JPB CAC

From: Roland Lebrun <ccss@msn.com>
Sent: Wednesday, January 11, 2023 9:46 AM
To: Transbay Info
Cc: SFCTA Board Secretary; MTABoard@SFMTA.com; Board (@caltrain.com); BART Board; SFCTA CAC; TJPA CAC; cacsecretary [@caltrain.com]; cac@sfmta.com
Subject: TJPA 1/12 Board Item 14 DTX 2018 SEIR CEQA Addendum
Attachments: Item 14 DTX 2018-FSEIR-2022 Addendum.pdf

2018 FSEIR Addendum

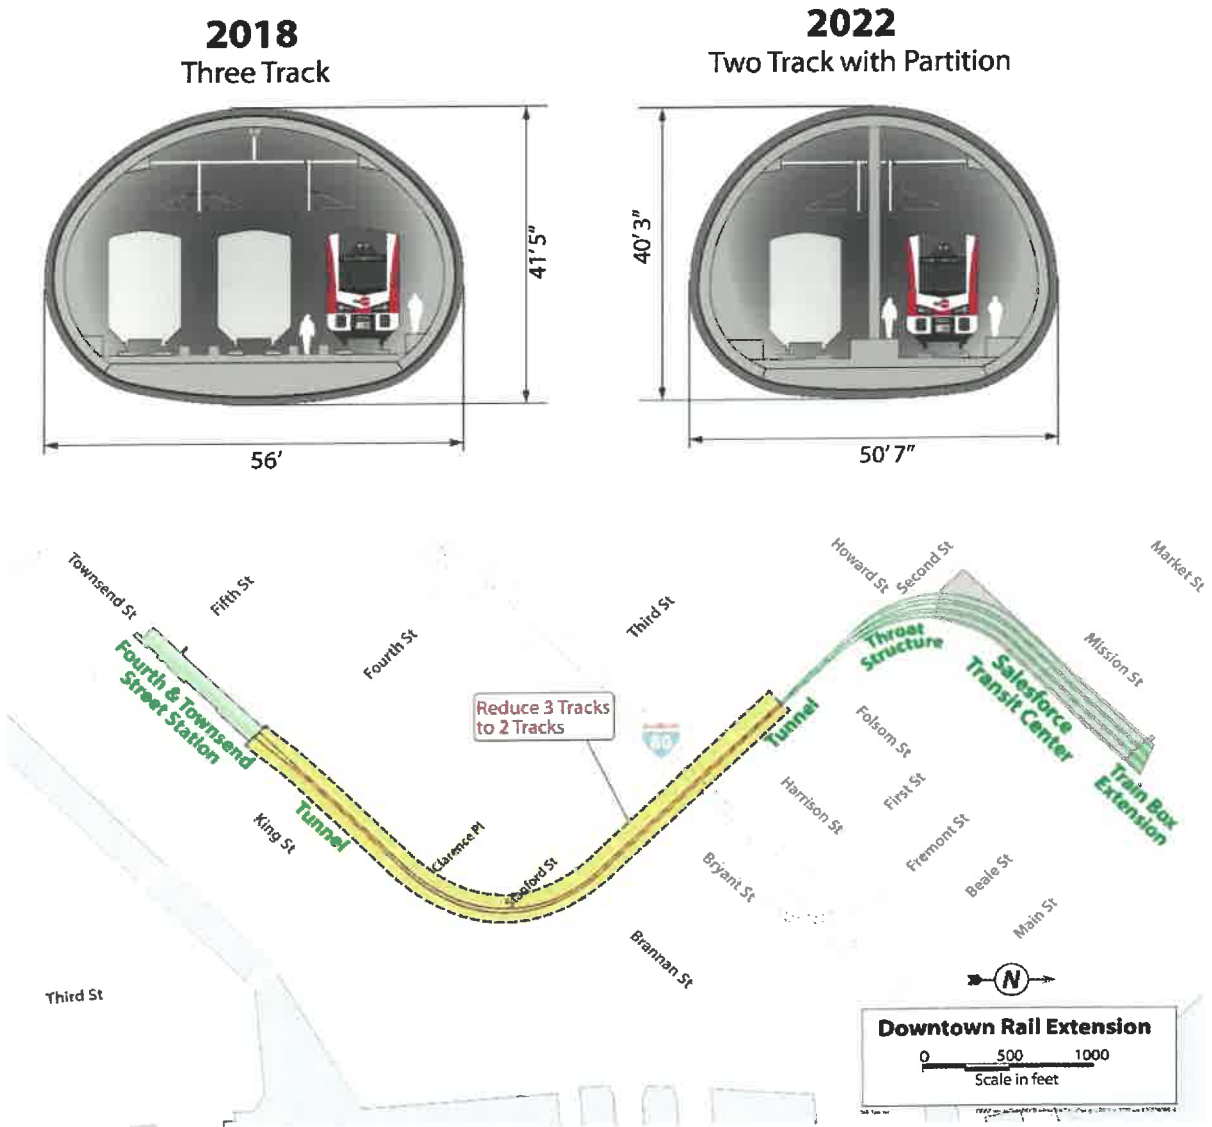
Please refer to the February 24 2021 Polechronis memo which characterized the 7th Street alignment alternative as unfeasible because:

"The two single-track tunnels proposed would constrain operations, create safety risks, and pose maintenance challenges. In February 2018, SFCTA's peer review panel, made up of five construction, operations, and maintenance experts, identified a need for three tracks into and out of the station to allow for anticipated operational inconsistencies without affecting train travel up and down the Peninsula main line"

3) Train box extension poses an existential threat to Next Transbay Rail Crossing (NTRC)

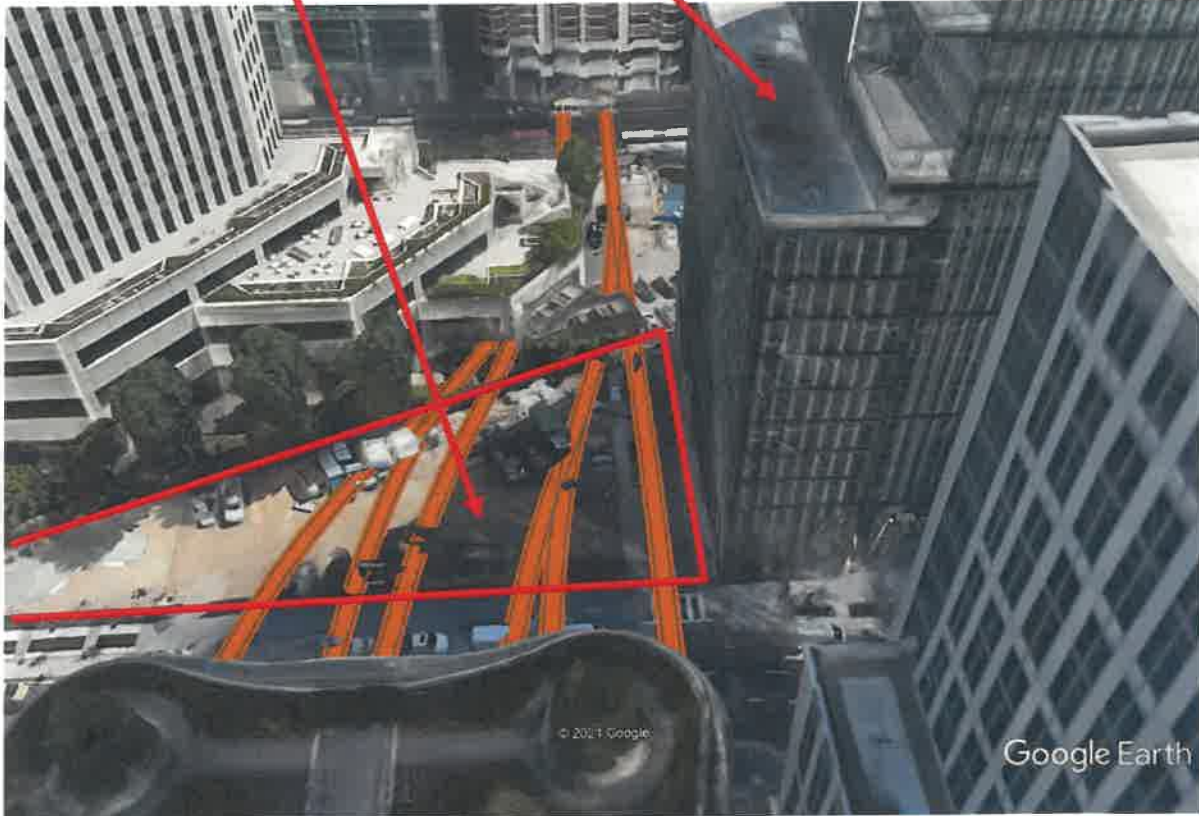
This is the second time the TJPA have carelessly imperiled the viability of a future East Bay connection, starting with the disposal of “Block 5” for \$175M to fund Phase I cost overruns back in 2015 (“Block 5” was a Phase II parcel reserved for the environmentally cleared NTRC Howard alignment).

Transfer responsibility for the development of the train box extension, the intercity bus facility and the taxi staging area to an SFCTA/MUNI/BART/DPW partnership responsible for designing and delivering the NTRC (LINK21) section between Beale Street and Embarcadero.

Caltrain Engineering Standards Chapter 7 Grade crossings (Page 28)

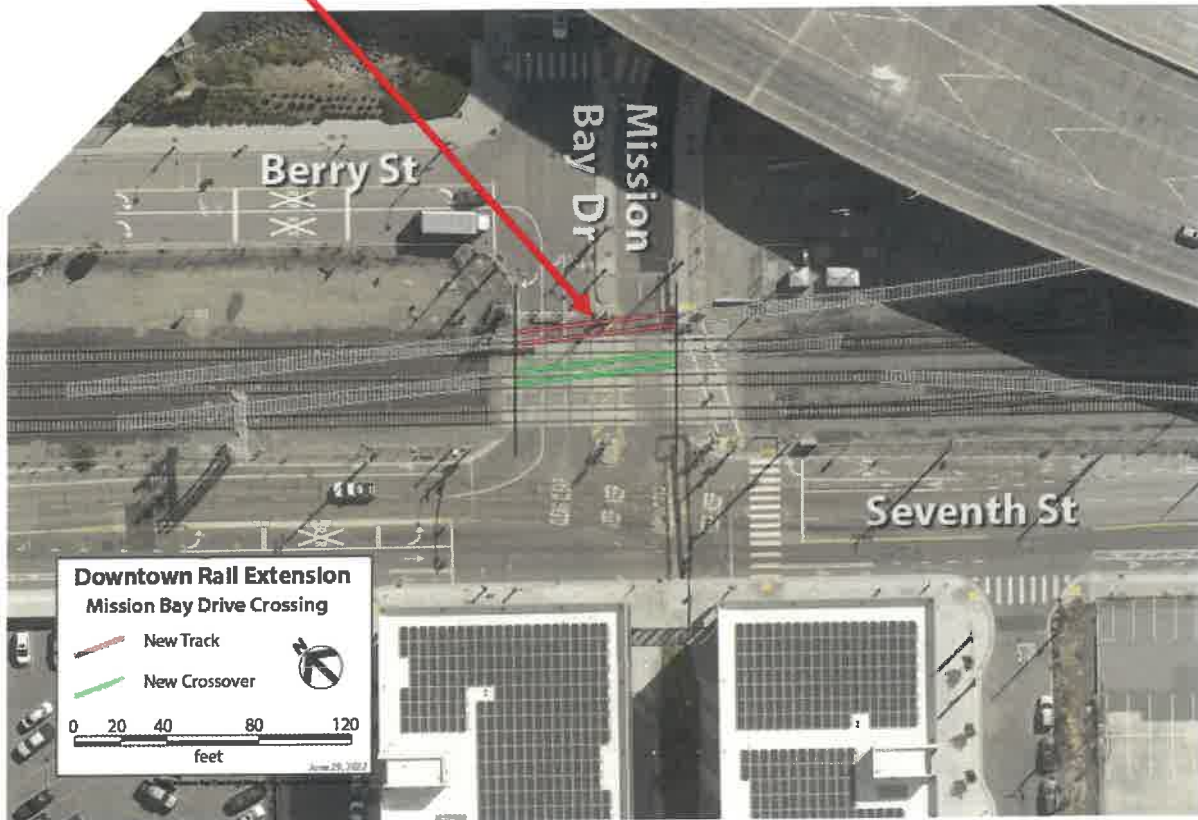
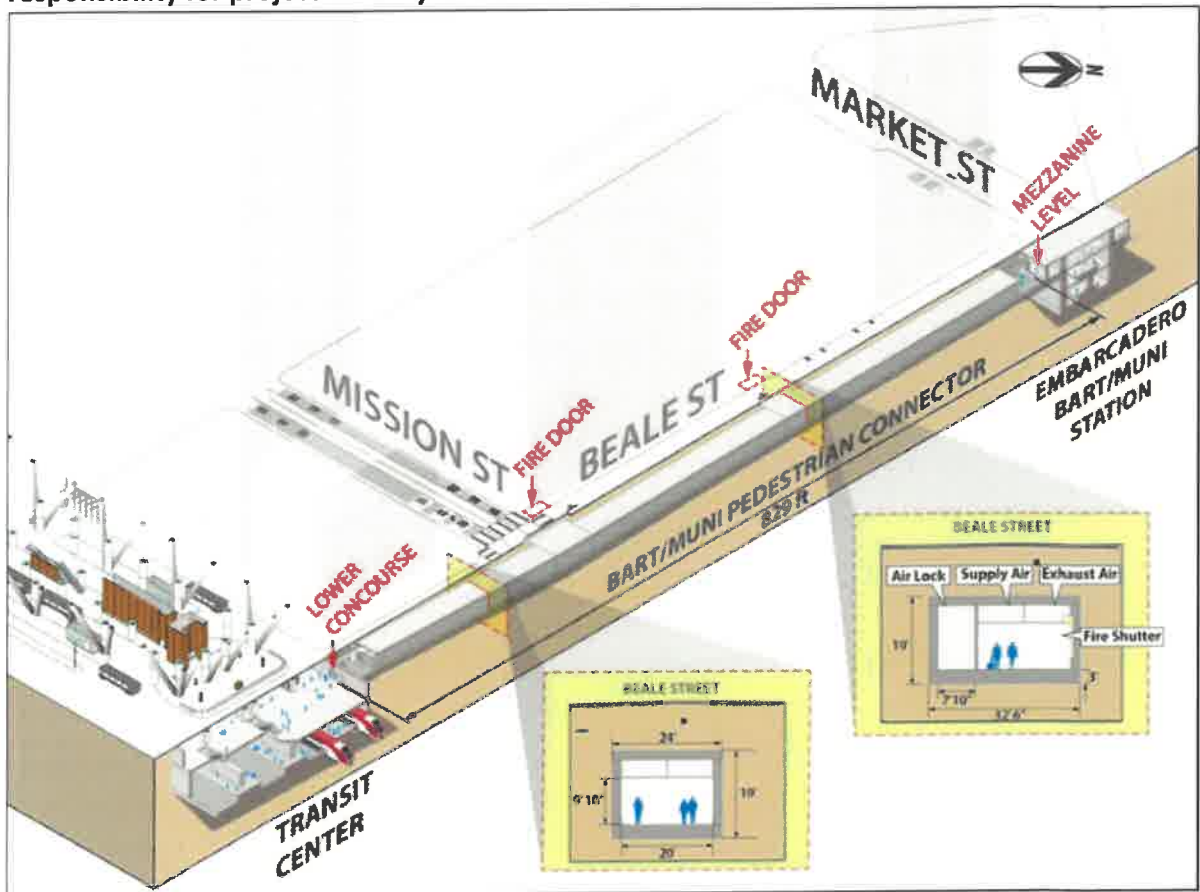
4) Proposed 4th track at Mission Bay Drive violates Caltrain engineering standards

"Caltrain does not have and does not allow at-grade crossings where there are four tracks."

6) **Fourth & Townsend station design introduces a single point of failure**

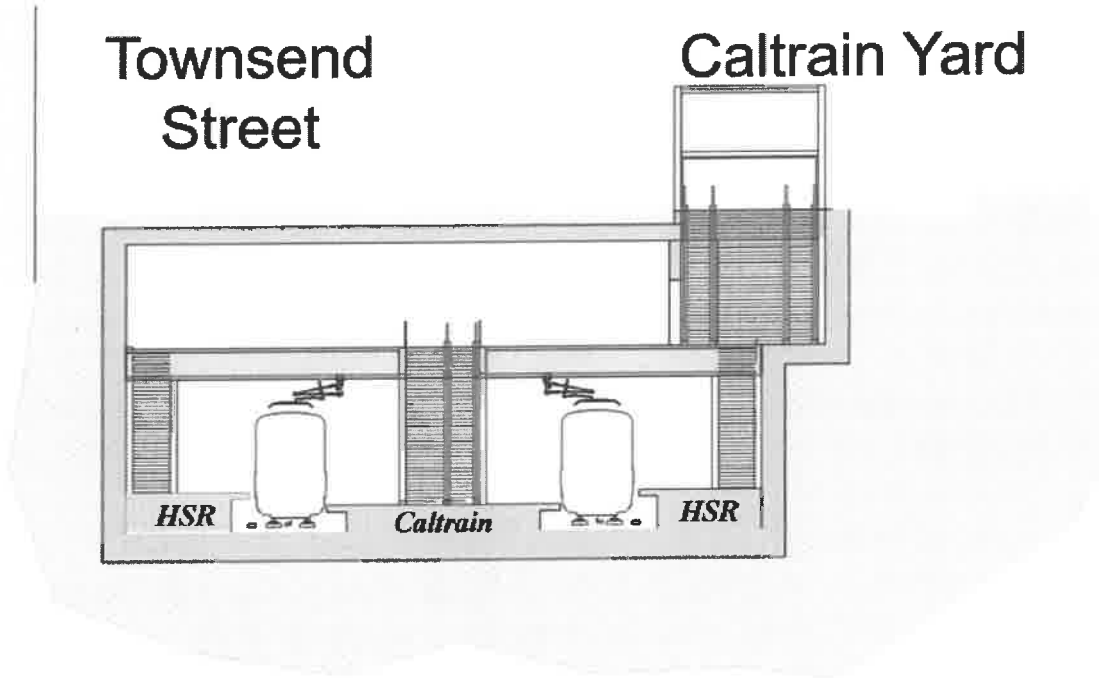
The elimination of passing track(s) makes it impossible to pass through the station in the event of an emergency
